Re: Petition No. Petition 1291 - 1710/1730 Lines Upgrade Project

Response to CSC-02 Interrogatories dated 04/07/2017  
CSC-009, 010, 011, 012

**TOWANTIC 1710/1730  
LINE UPGRADES PROJECT**

FIGURE 2 - AOC-5: FORMER COALASH DISPOSAL AREA

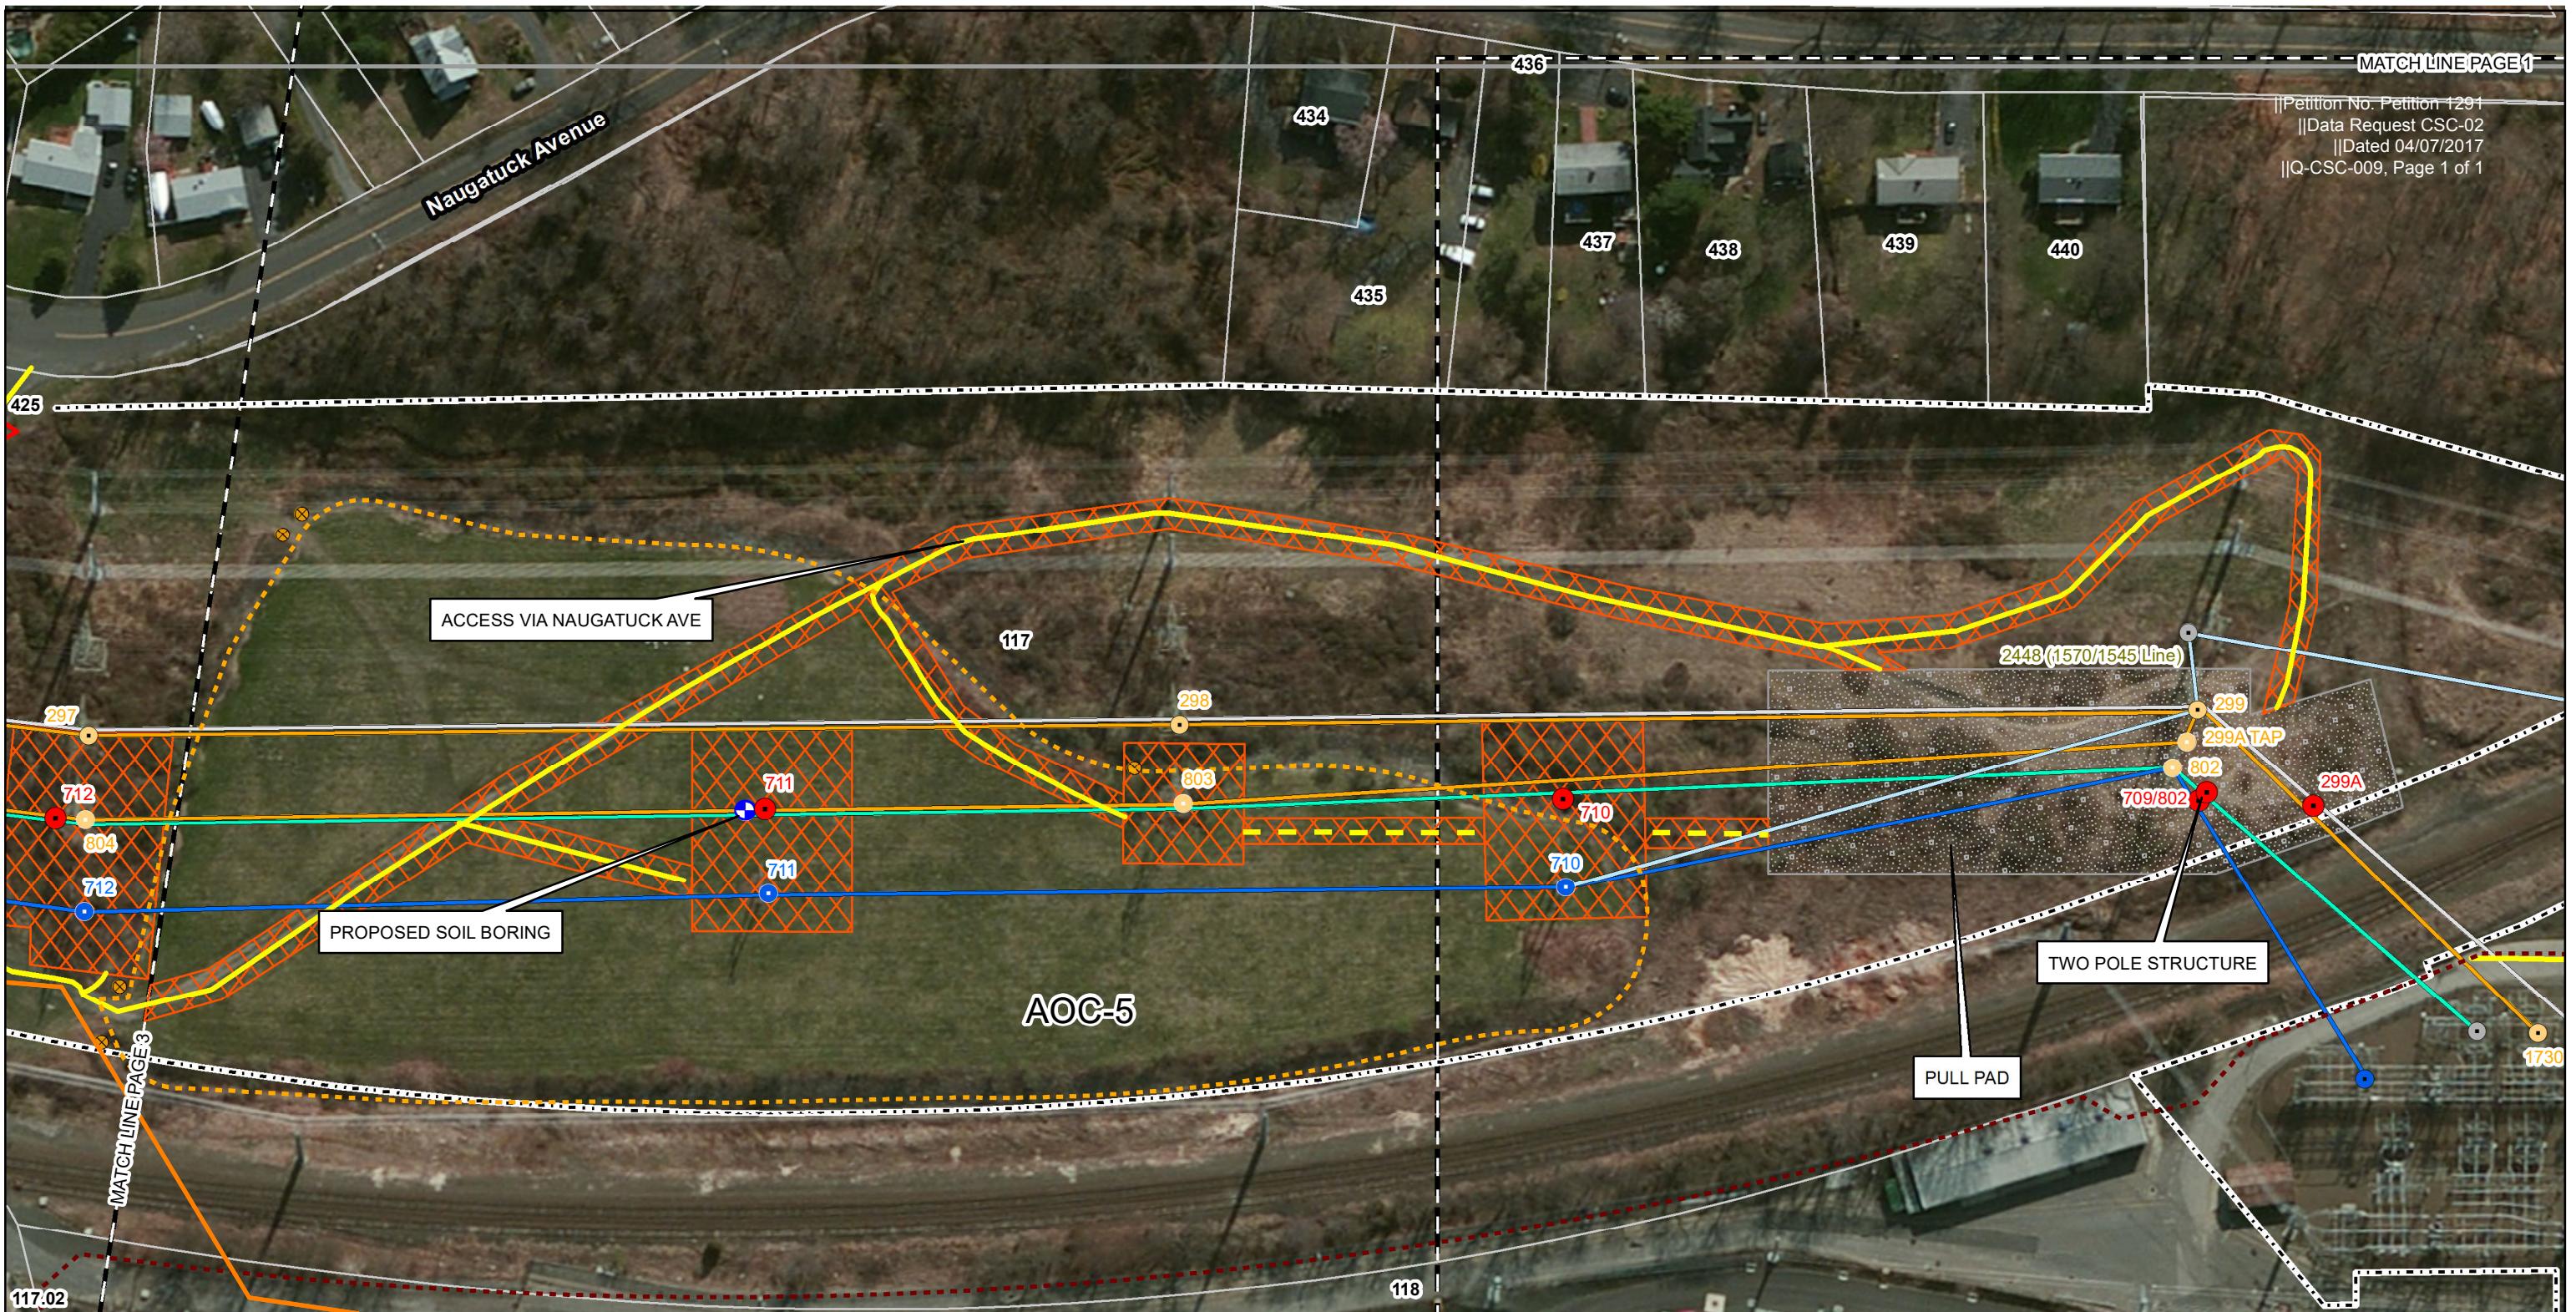
Would any of the proposed structures adjacent to the NRG Devon Power LLC facility be located within a former landfill area and/or environmental restricted use area? Explain. If yes, identify the number(s) of such structure(s), e.g. 709/802. Could such structure(s) be relocated outside of the landfill area/environmental restricted use area in order to avoid disturbing such areas?

The proposed project will install one new structure (proposed Structure 711) in a former coal ash disposal area. Three existing structures would be removed in this area, existing Structures 710, 711 and 803. These structure removals would not entail below grade disturbance since we are cutting the structures at grade and leaving the underground foundations in place. The attached Figure 2 shows these structures and the former coal ash disposal area.

Eversource's existing right-of-way easement area spans the the former coal ash disposal area. Though it was possible to relocate Structures 710 and 803 out of the disposal area, it is not possible to similarly relocate replacement Structure 711, due to the span length, unless the easement area, itself, were to be relocated out of the disposal area.

Eversource also examined not installing proposed Structure 711 and having a longer span between proposed Structures 710 and 712/804. However, this would require increasing the height of the adjacent proposed Structures 710 and 712/804 from approximately 95 feet to 135 feet. Additionally, it would require modification to the adjacent transmission lines to accommodate the increased blowout from this long span.
